Customer Service Bulletin SD800007 Cable Issues in SE500 Rack Mount Transmitters

Application: This bulletin applies to **SE500 Rack Mount Transmitter SLF34002**. This applies to SE transmitters shipped prior to February 15, 2013.

Example #1 - 9C012047 Cable Replacement, SLF34002 (SE500 Rack Mount Dual Transmitters):

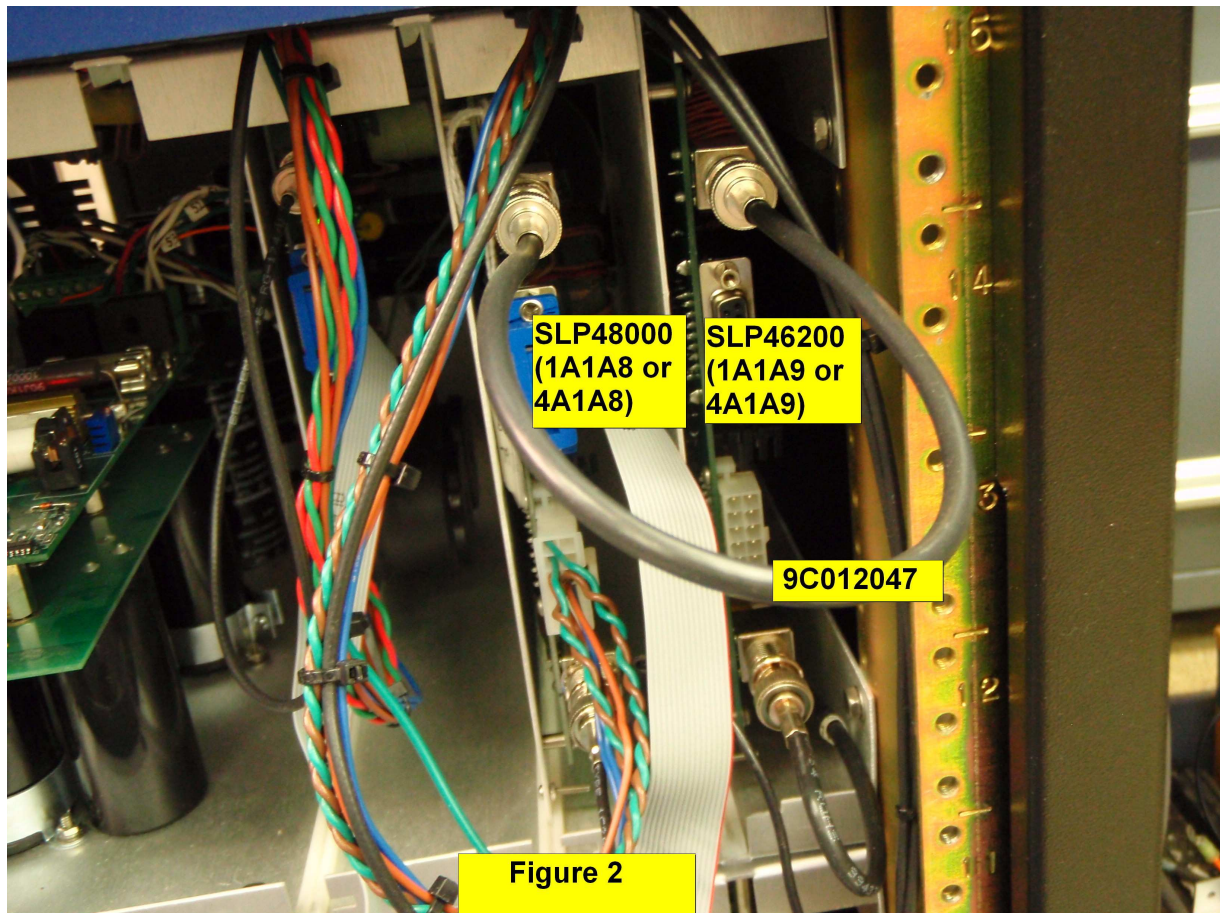
- Disconnect the 9C012047 cable from J1 on the SLE46200 Filter Bridge Module 1A1A5, located on the left-hand side of the upper transmitter unit per Figure 1.
- Disconnect the other end of the 9C012047 cable from J2 the SLE48000 SPA Module 1A1A4, located on the left-hand side of the upper transmitter unit per Figure 1.
- Repeat the above steps on the SLE46200 Filter Bridge Module 4A1A5 and SLE48000 SPA Module 4A1A4 located on the left-hand side of the lower transmitter unit per Figure 1.
- Install replacement cables 9C012065 in place of the two (2) cables removed.

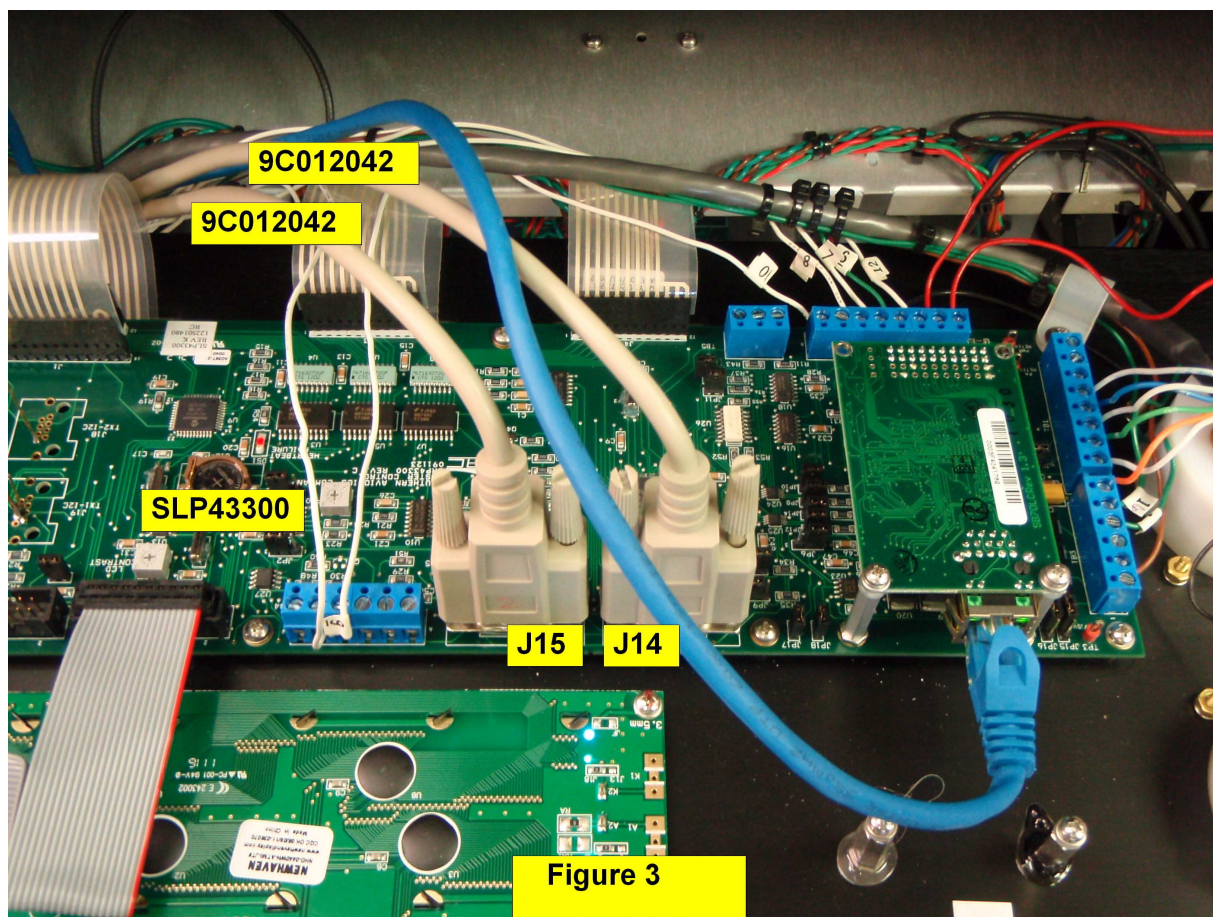
- Disconnect the 9C012047 cable from J1 on the SLE46200 Filter Bridge Module 1A1A9, located on the right-hand side of the upper transmitter unit per Figure 2.
- Disconnect the other end of the 9C012047 cable from J2 the SLE48000 SPA Module 1A1A8, located on the right-hand side of the upper transmitter unit per Figure 2.
- Repeat the above steps on the SLE46200 Filter Bridge Module 4A1A9 and SLE48000 SPA Module 4A1A8, located on the right-hand side of the lower transmitter unit per Figure 2.
- Install replacement cables 9C012065 in place of the two (2) cables removed.

Example #2 - 9C012042 Cable Replacement, SLF34002(SE500 Rack Mount Dual Transmitters):

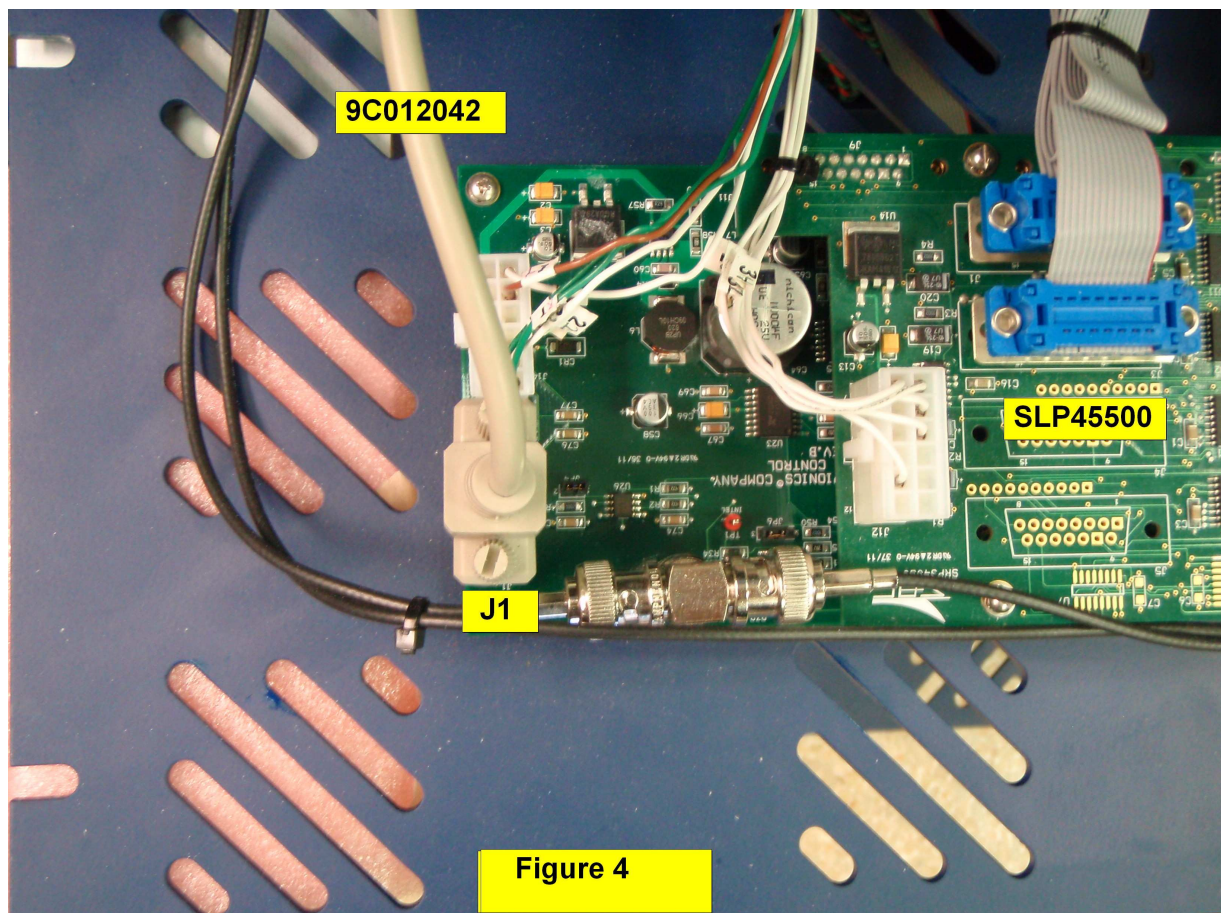
- Disconnect the 9C012042 cable from J14 on the SLP43300 Master Control PCB (5A1A1) per Figure 3.
- Disconnect the other end of the 9C012042 cable from J1 on the SLP45500 Transmitter Control PCB in transmitter #1 (1A1A1) per Figure 4.
- Install replacement cable 9C012061 in place of the cable removed using tie wraps provided.
- Disconnect the 9C012042 cable from J15 on the SLP43300 Master Control PCB (5A1A1) per Figure 3.
- Disconnect the other end of the 9C012042 cable from J1 on the SLP45500 Transmitter Control PCB in transmitter #2 (4A1A1) per Figure 4.
- Install replacement cable 9C012061 in place of the cable removed using tie wraps provided.
- Dispose of cables per local standards.
